Project	IEEE 802.16 Broadband Wireless Access Working Group < http://ieee802.org/16 >	
Title	Modified DL subcarrier to resource unit mapping	
Date Submitted	2008-07-16	
Source(s)	<p>Taeyoung Kim Jeongho Park Junsung Lim Jaeweon Cho Hokyung Choi Heewon Kang</p> <p>Samsung Electronics</p> <p>Sophie Vrzic Dongsheng Yu Mo-Han Fong Robert Novak Steve Yuan Hosein Nikopourdeilami</p> <p>Nortel</p> <p>Jong-kae (JK) Fwu Hujun Yin Huaning Niu Yuval Lomnitz Sassan Ahmadi</p> <p>Intel Corp.</p>	<p>ty33.kim@samsung.com, jeongho.jh.park@samsung.com, junsung.lim@samsung.com jaeweon.cho@samsung.com, choihk@samsung.com hkang@samsung.com</p> <p>svrzic@nortel.com dongshengyu@nortel.com mhfong@nortel.com rnovak@nortel.com junyu@nortel.com hosein@nortel.com</p> <p>Jong-kae.Fwu@intel.com Hujun.Yin@intel.com Huaning.Niu@intel.com Yuval.Lomnitz@intel.com Sassan.Ahmadi@intel.com</p>
Re:	IEEE 802.16m-08/024, "Call for Comments and Contributions on Project 802.16m System Description Document (SDD)". Target topic: "DL Physical Structure"

Modified DL subcarrier to resource unit mapping

Figure 1 Illustration of the downlink subcarrier to resource [block-unit](#) mapping

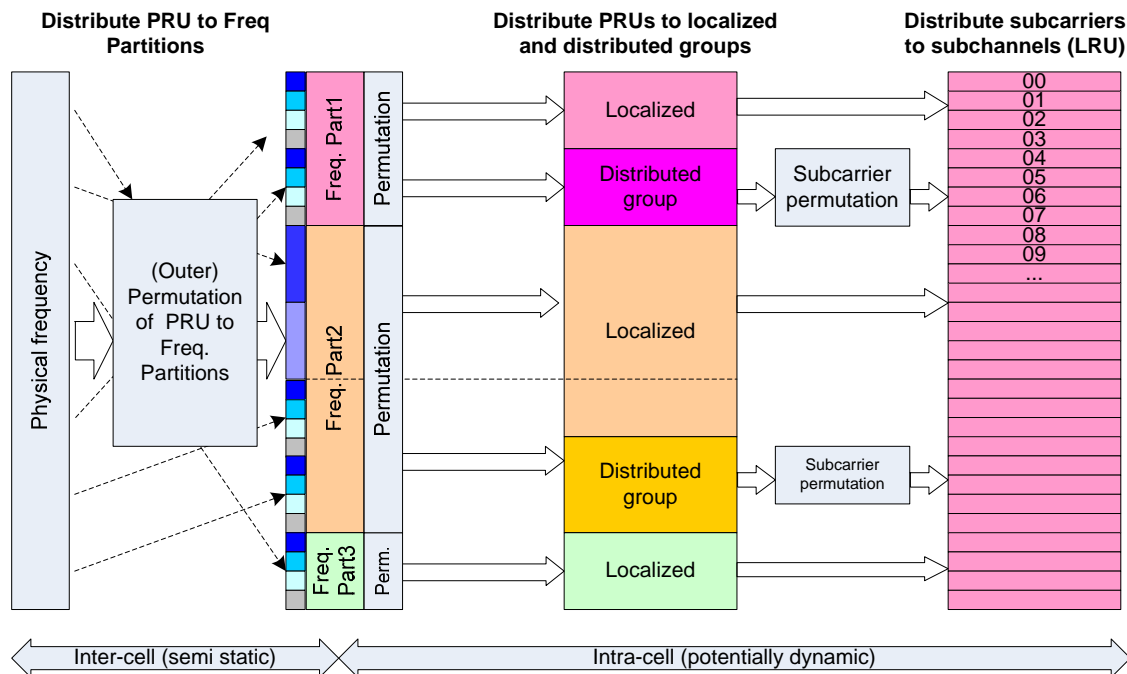
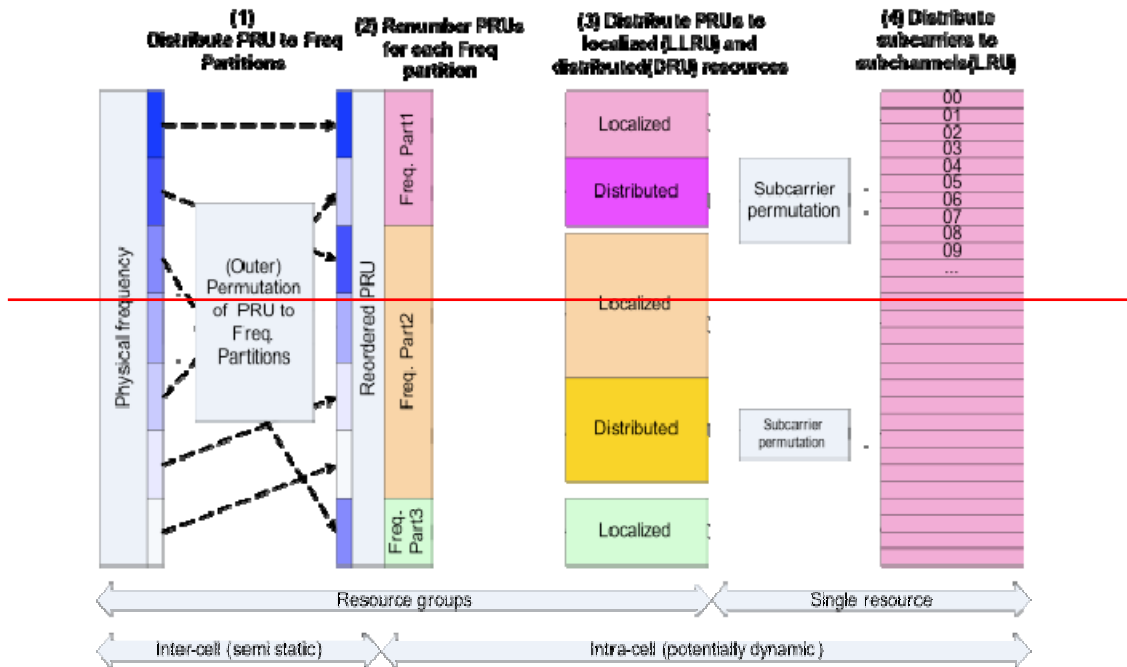
Change the text in Downlink subcarrier to resource unit mapping Sub-clause as follows:

1. First-level or outer permutation is applied to the PRUs in the units of $N1$ and $N2$ PRUs, where $N1 = 4$ (TBD) and $N2 = 1$ or 2 depending on system bandwidth (TBD). Direct mapping of outer permutation can be supported.
2. Distributed PRUs into frequency partitions.
3. The frequency partition is divided into localized(LLRU) and/or distributed(DRU) resources for each resource **using the PRU as unit for each resource.** Using sector specific permutation can be supported; directly mapping of the resources can be supported for localized resource. The sizes of

the groups are flexibly configured per sector (TBD). Adjacent sectors do not need to have same configuration of localized and [distributed resources](#). ~~diversity groups~~.

- The localized and distributed groups are further mapped into LRUs (by direct mapping of LLRU and by “Subcarrier permutation” on DRUs) as shown in the following figure.
